Subject: Response to the Staff's Questions Regarding the Root Cause Evaluation for
Steam Generator Tube Rupture Event of February 15, 2000 (TAC No.
MA8219)

Response to Root Cause Evaluation Issues Nos. 4, and 15

Consolidated Edison Company of New York, Inc.
Indian Point Unit No. 2
Docket No. 50-247
June 2000

24 Steam Generator Leak Rate - N-16

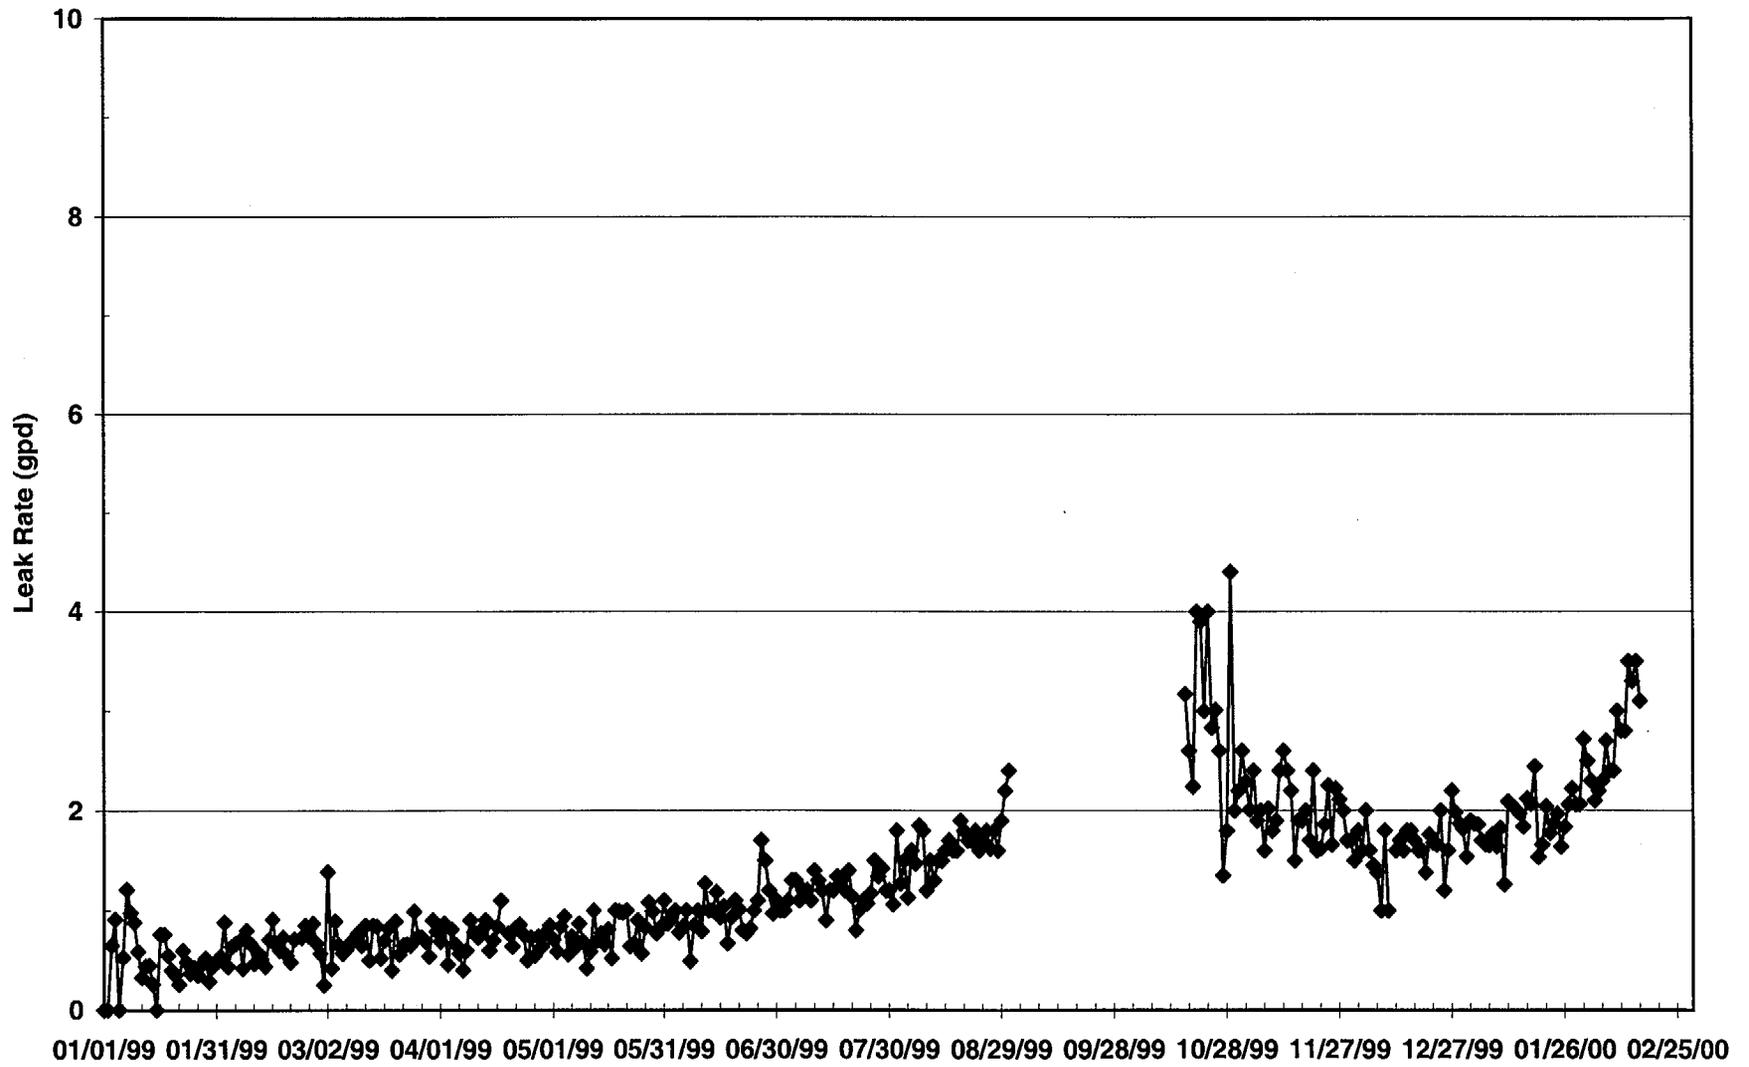
What were the N-16 leakage measurements as a function of time in the hours and minutes leading up to the event? What was the time interval between the last reading and the failure event?

What were the air ejector rad monitor readings during the hours and minutes leading up to the event?

On February 15, 2000 at approximately 1915 hours, the N-16 monitor was indicating 3.4 gpd. The steam generator tube rupture event had initiated at approximately 1929 hours. A graph illustrating 24 steam generator primary to secondary leakage, as indicated by the N-16 monitor, is attached.

A graph illustrating the primary to secondary leakage rates, as derived by the air ejector radiation monitor readings from January 1, 1999 until just before the event, is attached.

REACTOR COOLANT LITHIUM

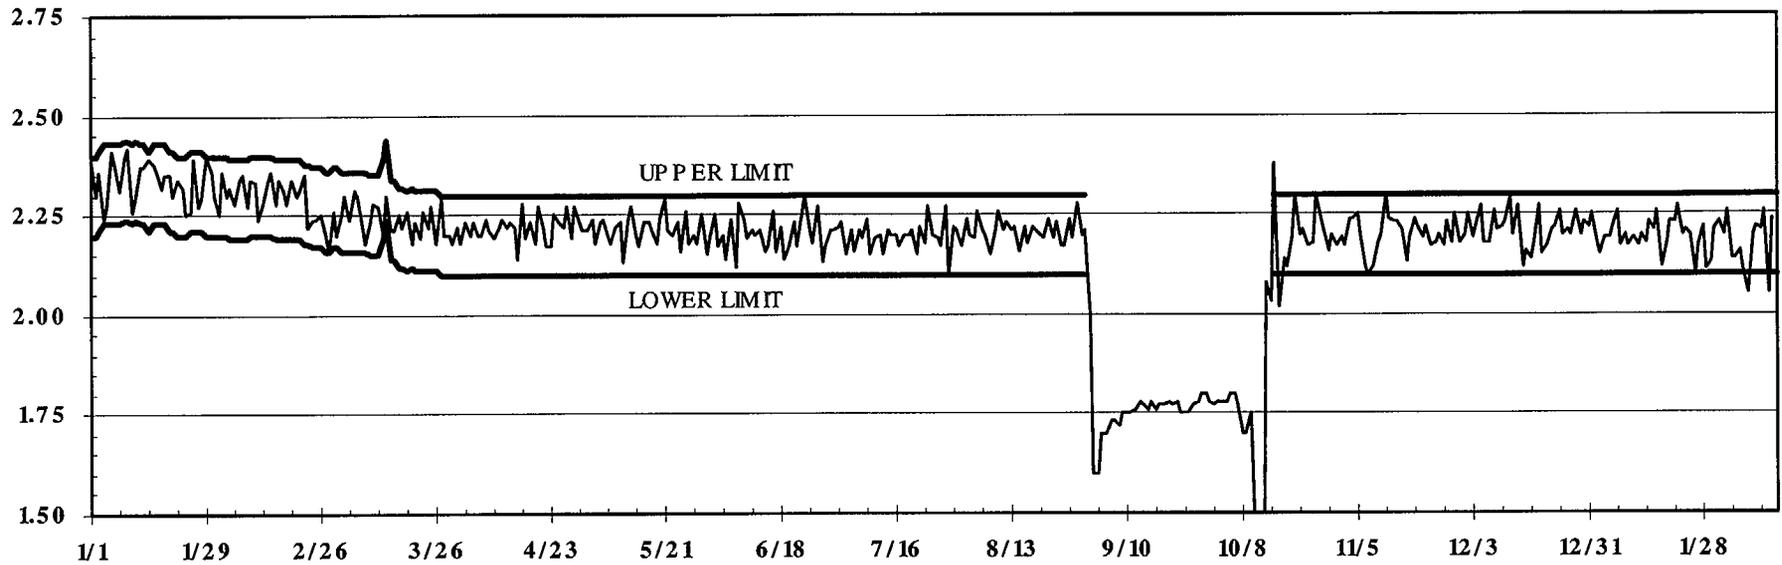
The root cause report should assess primary water chemistry as a potential contributing factor.

Based upon a review of the primary water chemistry history during the past operating cycle, Con Edison believes that water chemistry did not contribute to the occurrence of primary water stress corrosion cracking (PWSCC), which is the identified root cause for the tube leak. The primary system chemistry parameters reviewed for the operating cycle were boron/lithium concentration and hydrogen concentration. Boron/lithium concentration, which controls the pH, was maintained with procedural limits. Hydrogen concentration was also maintained within an approved band of 25- 50 cc/kg.

Attached graphs illustrate both of the above mentioned chemistry parameters to have been maintained within acceptable limits during the previous operating cycle.
